# Division 2000: Pavement Systems

**DIVISION 2000 PAVEMENT SYSTEMS****TABLE OF CONTENTS**

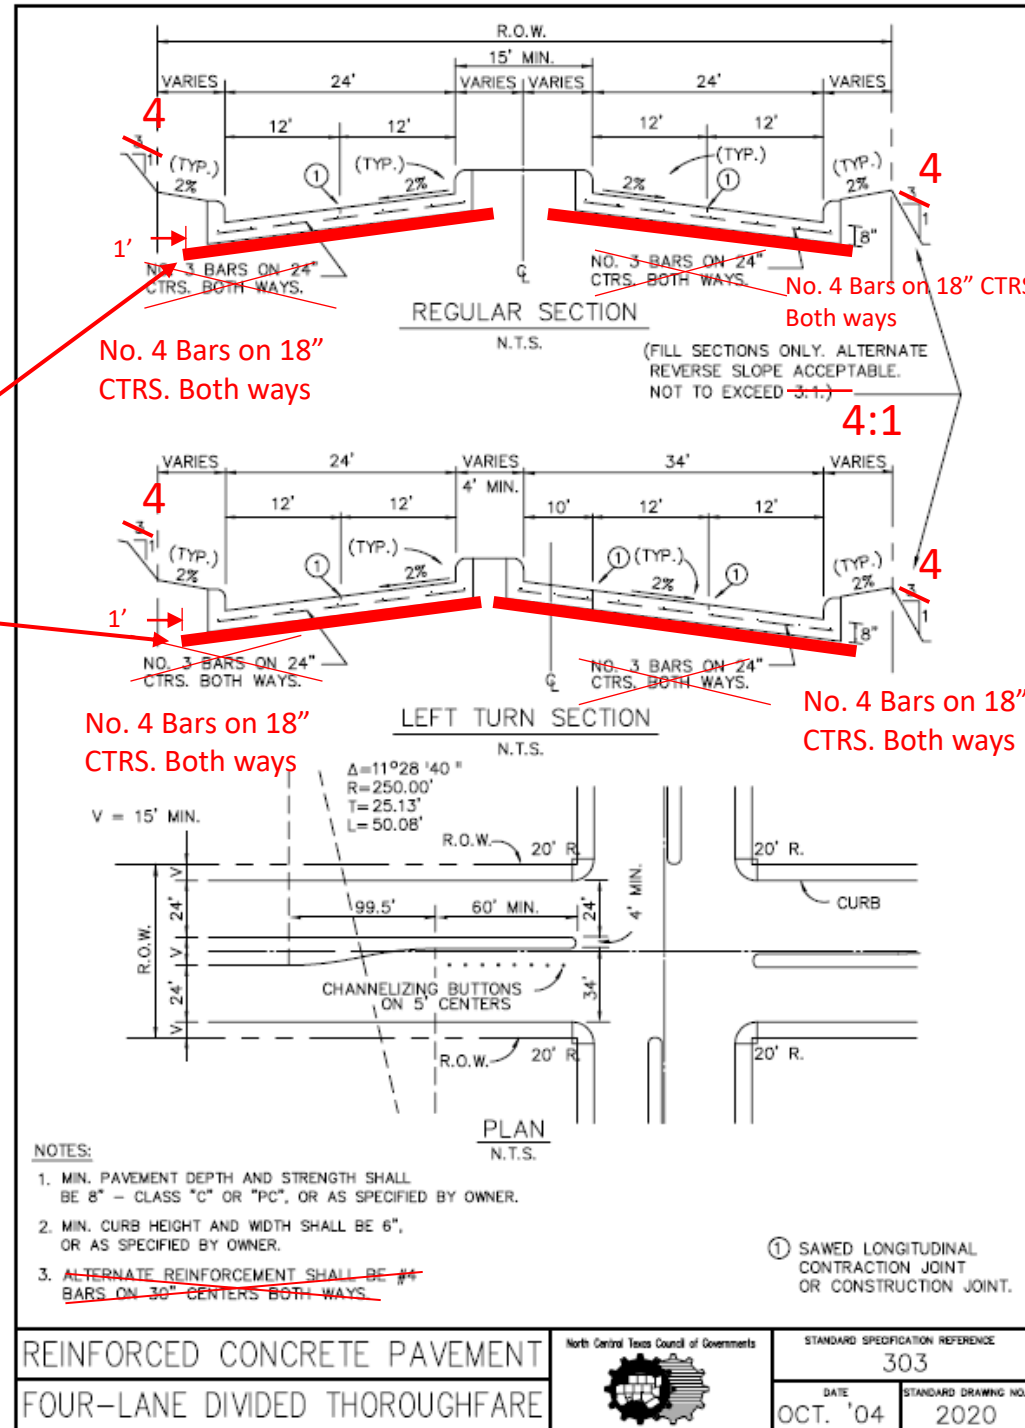
Make sure the format, text size, arrow size, etc. is consistent on the page.

Show subgrade box on all Division 2000 drawings.

Note 4 should not specify 40lbs/sy but refer to 301 in the specs.

Replace Plan with a more general layout to include crosswalks, ADA ramps, striping, and possibly additional lane width for bicycle lanes per TxDOT

2030

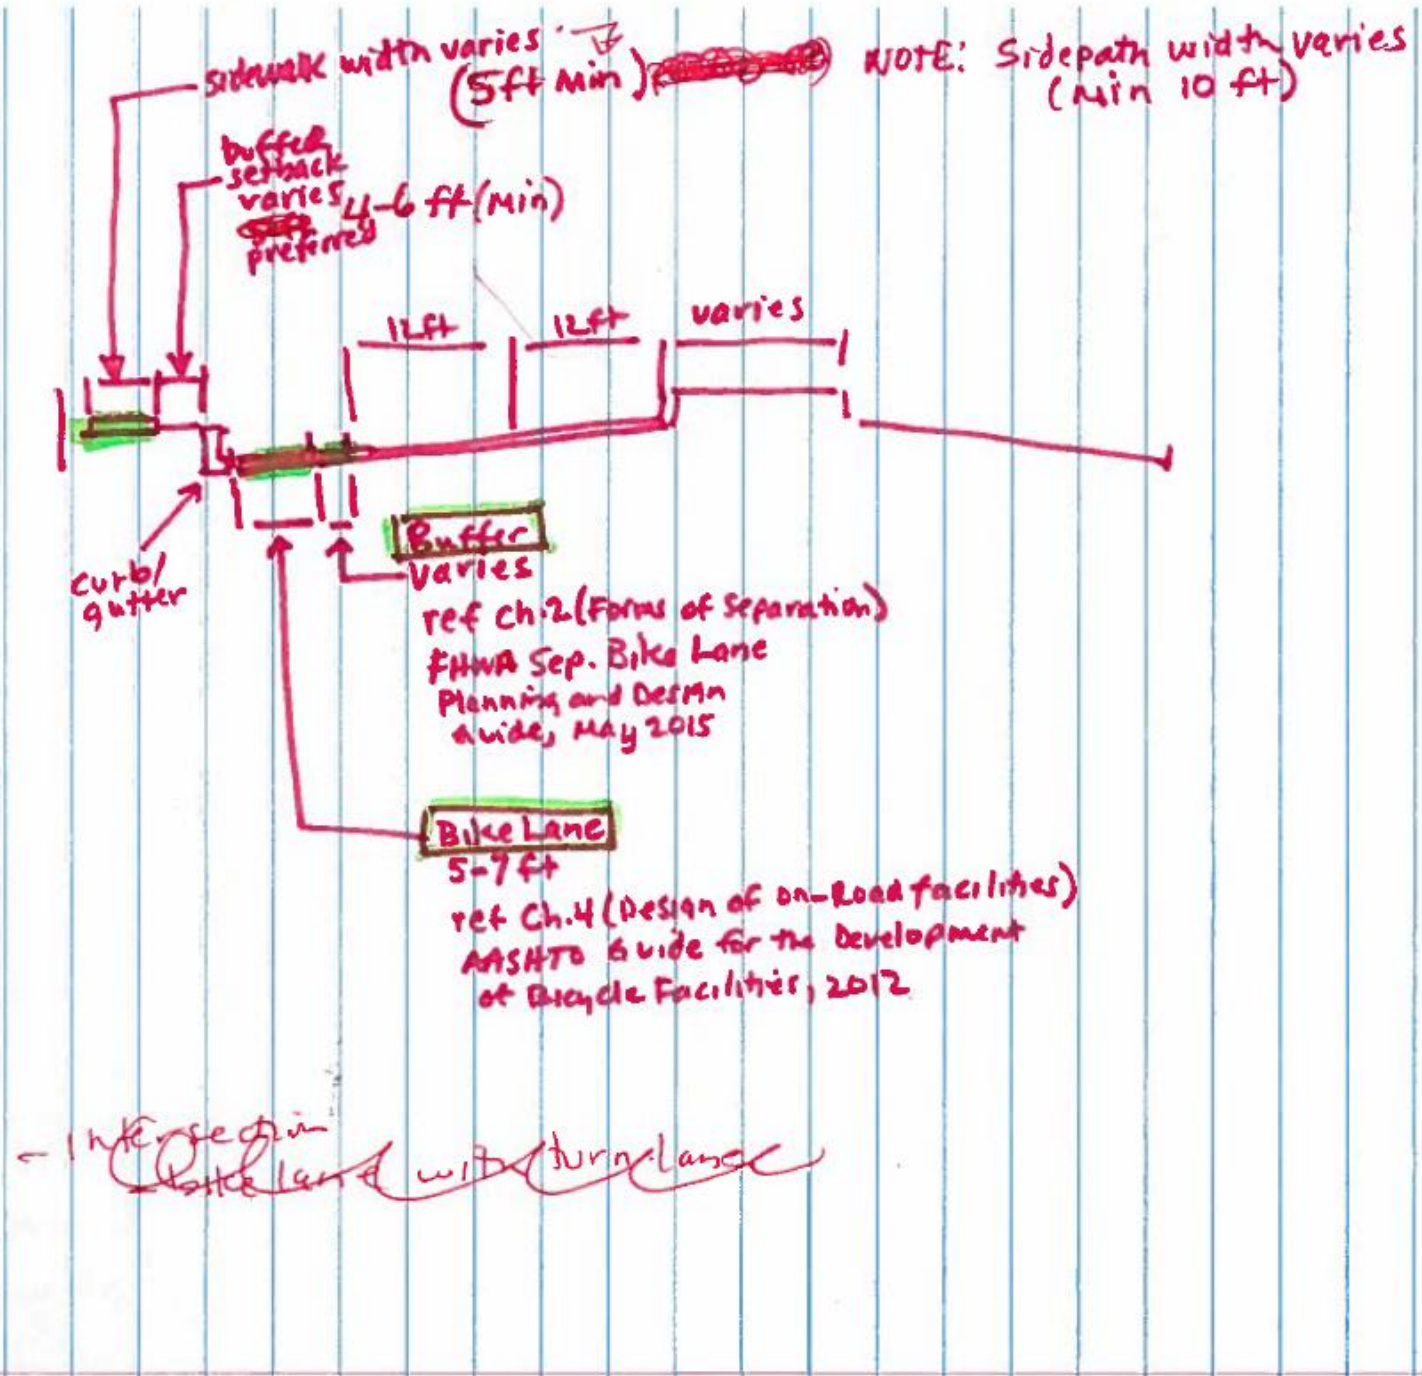
Make sure the format, text size, arrow size, etc. is consistent on the page.

Show subgrade box on all Division 2000 drawings.

Note 4 should not specify 40lbs/sy but refer to 301 in the specs.

Replace Plan with a more general layout to include crosswalks, ADA ramps, striping, and possibly additional lane width for bicycle lanes per TxDOT

Show a shared use path on the right side of the section details. Add note describing that two different options for multimodal transportation are being shown but installation should be specified by owner.

Shared path width is a minimum of 10'.

Everywhere with ASHTO note should say refer to note 5 and make it one note at the end.

If there's a required bike lane the buffer should be 1'-3' depending on the speed.

Sidewalks should be 5' as directed by city but can be reduced to a minimum of 3' sidewalk with 5' bulb out.

### LEFT TURN SECTION

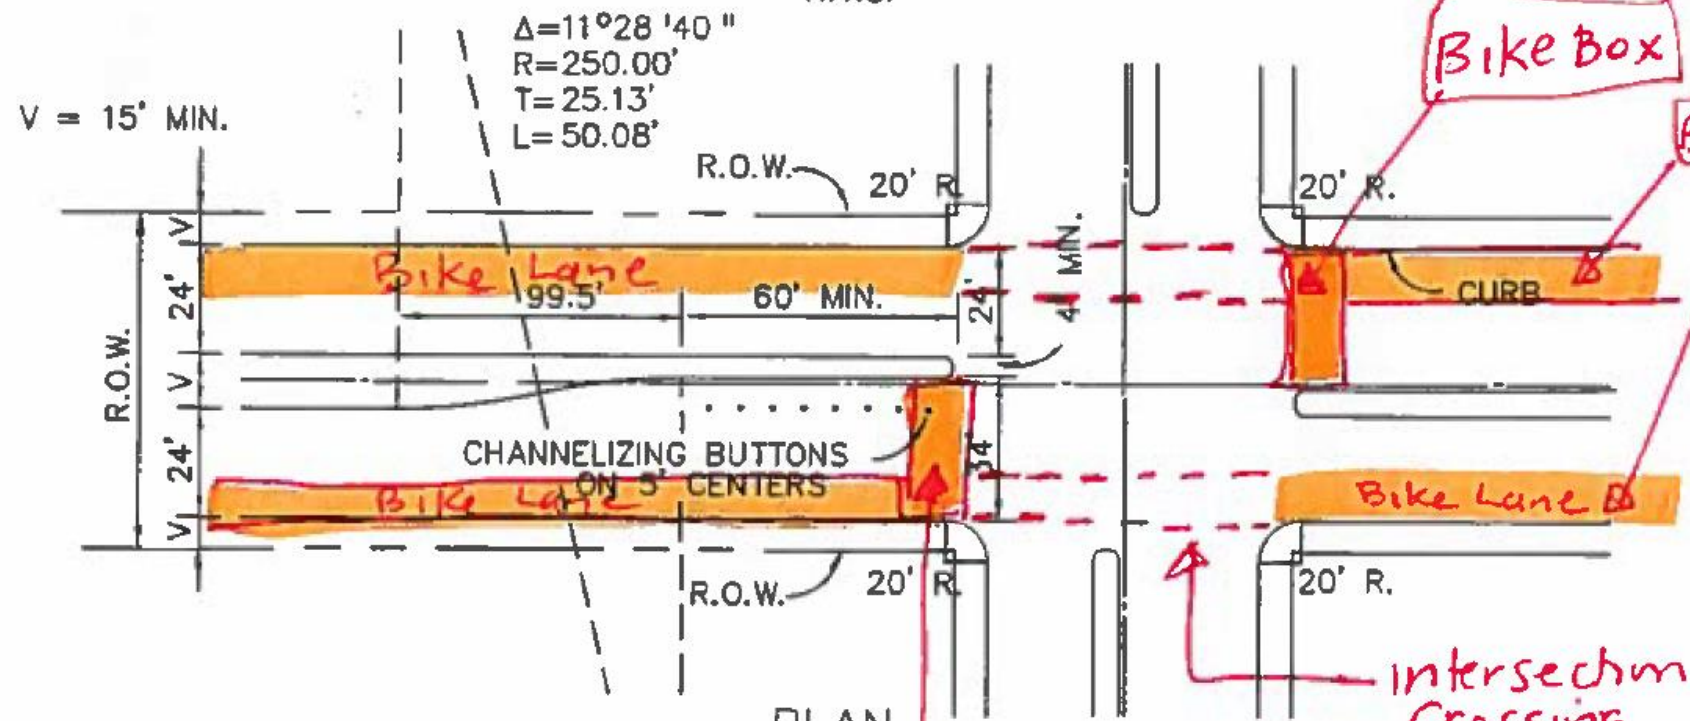
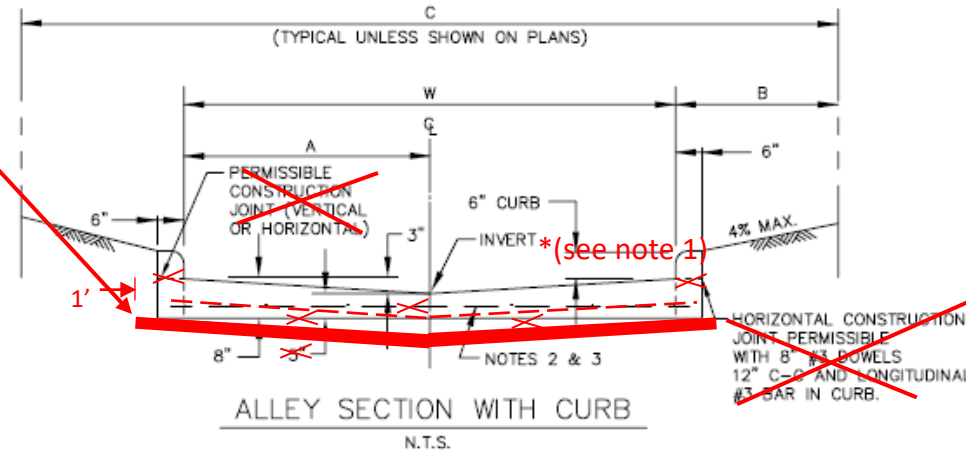
Chris will send markup of plan view.

Put the plan views on a separate page (2015 and 2025).

Show a plan view with bike lanes and without.

Remove bike box on plan view and get rid of ASHTO reference.

Add curb ramp, cross walk markings, and make sure the median nose is not in the cross walk on the plan view.

The radius for the curb on the plan view should be 30'.

*Don't use references from NACTO*

STANDARD DRAWING NO.  
2050

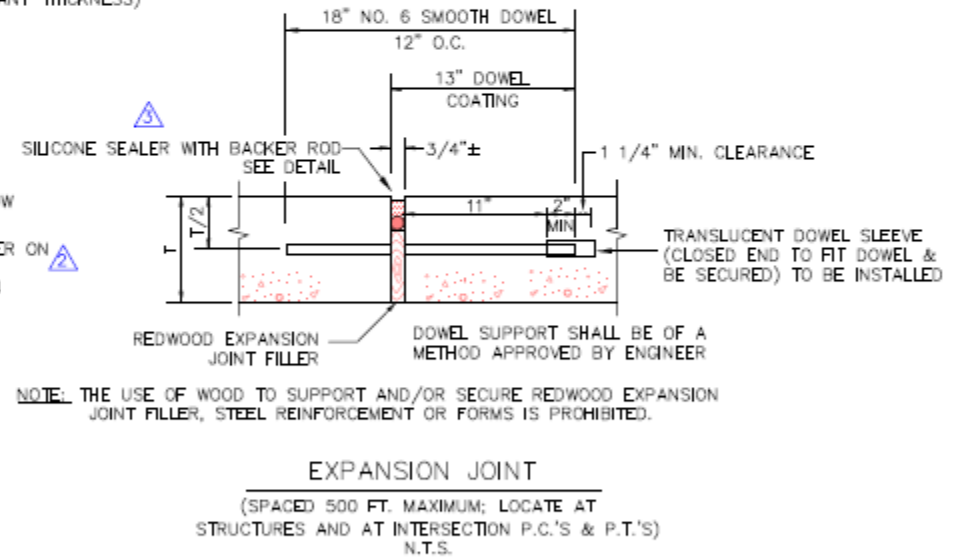
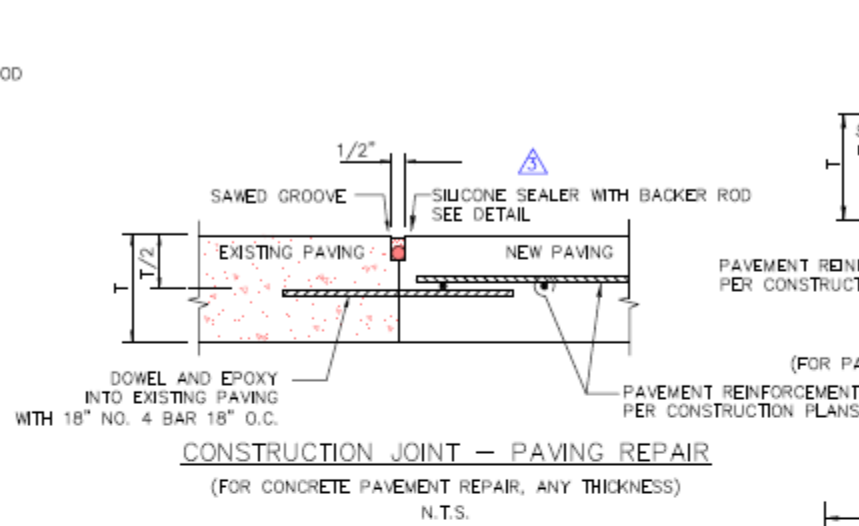
Show backer rod in detail, compare to Coppel detail 2050.

STANDARD DRAWING NO.  
2060

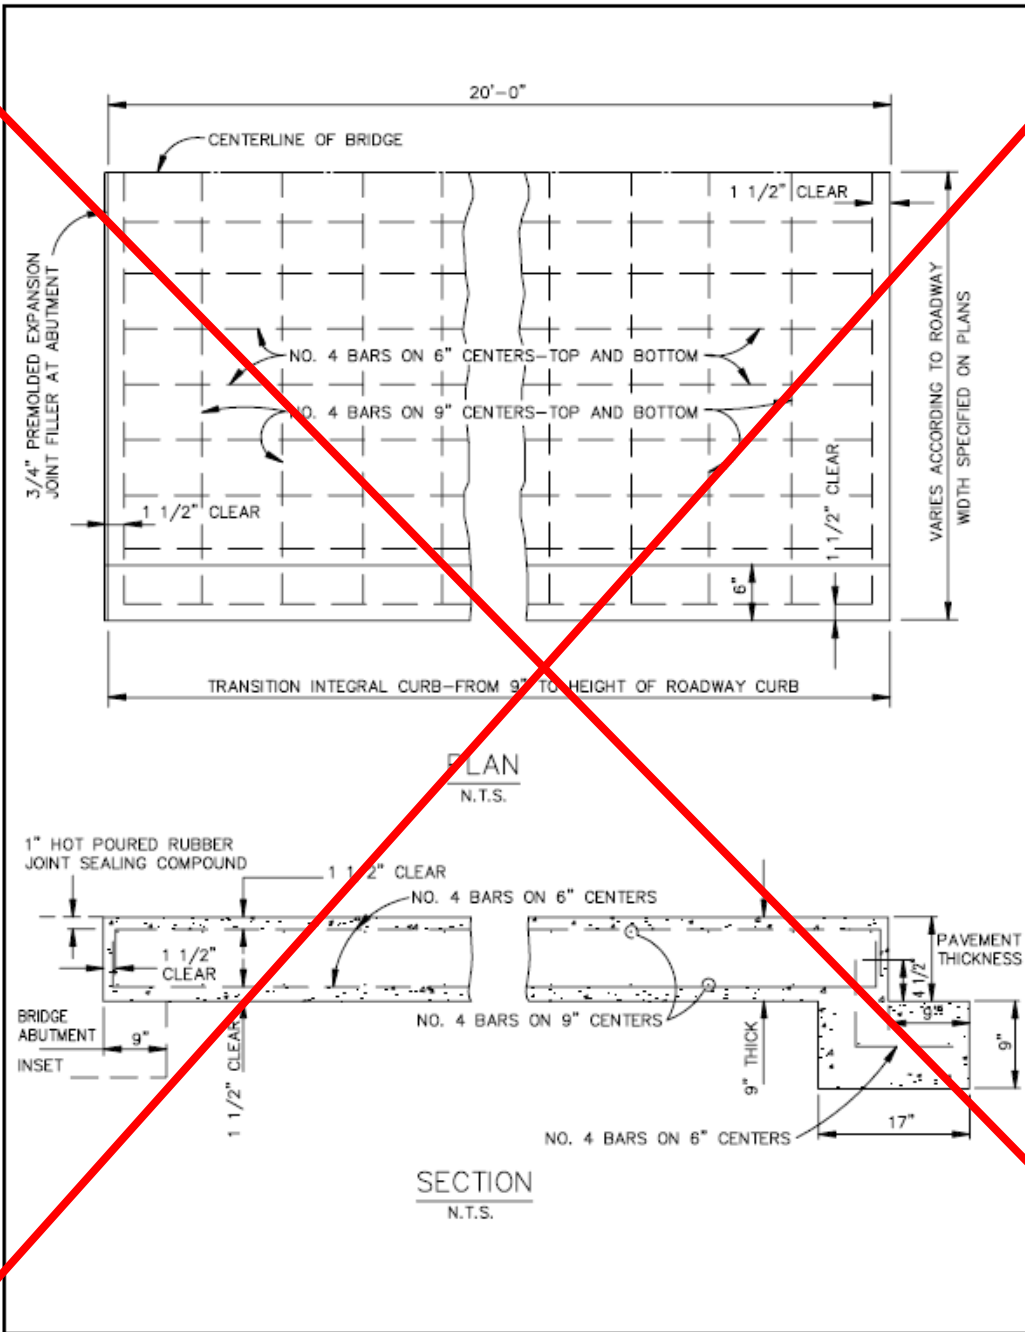
Add contraction joints like in Coppell 2060 detail.

\*cleanup lines through median

REINFORCED CONCRETE PAVEMENT	North Central Texas Council of Governments	STANDARD SPECIFICATION REFERENCE 303
BRIDGE APPROACH SLAB		DATE OCT. '04
		STANDARD DRAWING NO. 2080

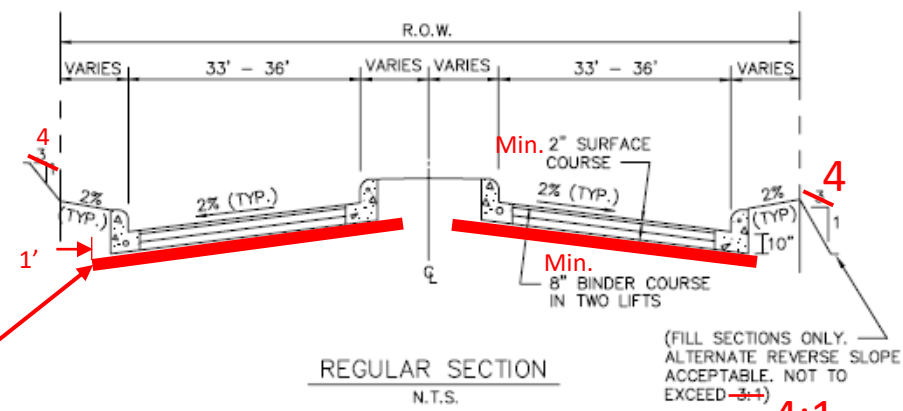
Remove detail and reference TxDOT detail in specs if needed

DOWELED CURB

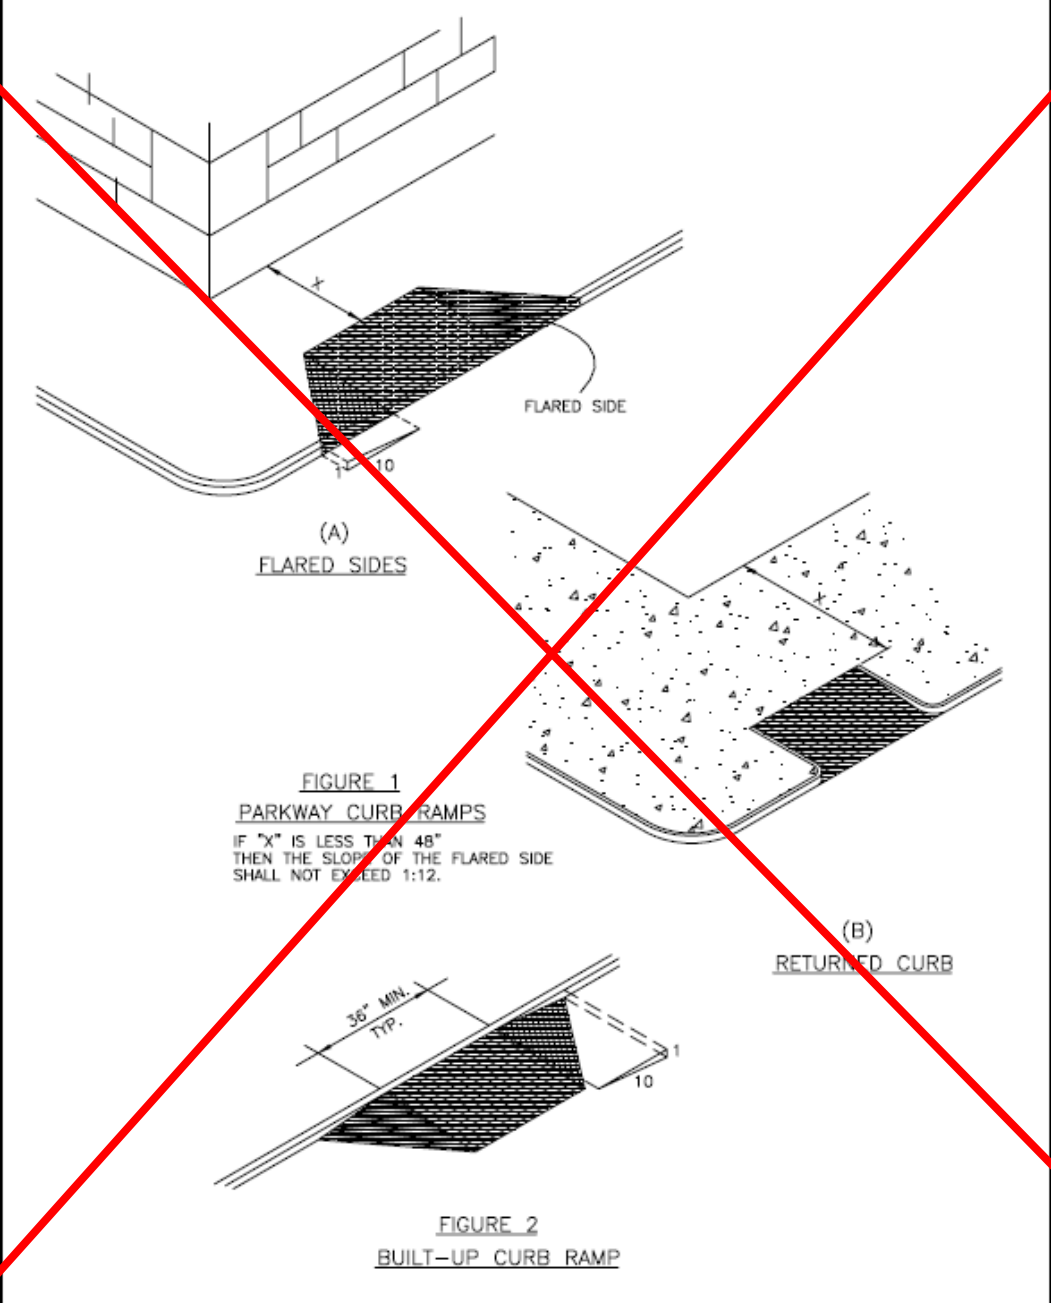
Make a note and graphical change on integral curb and gutter detail to show rebar.

CURB RAMPS	North Central Texas Council of Governments	STANDARD SPECIFICATION REFERENCE	
		DATE OCT. '04	STANDARD DRAWING NO. 2125A

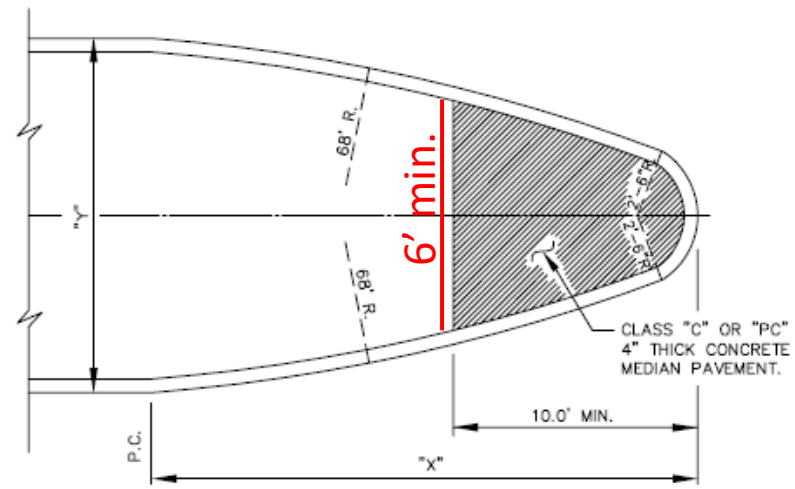
Update and remove 2125A or update to reference other detail

LEFT TURN LANE MEDIAN PAVEMENT

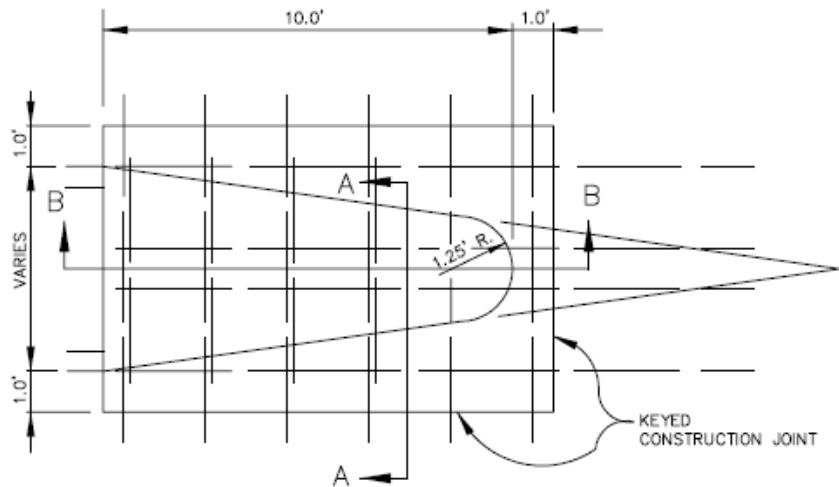
Move arrows to outside lines or change to "B. to B."
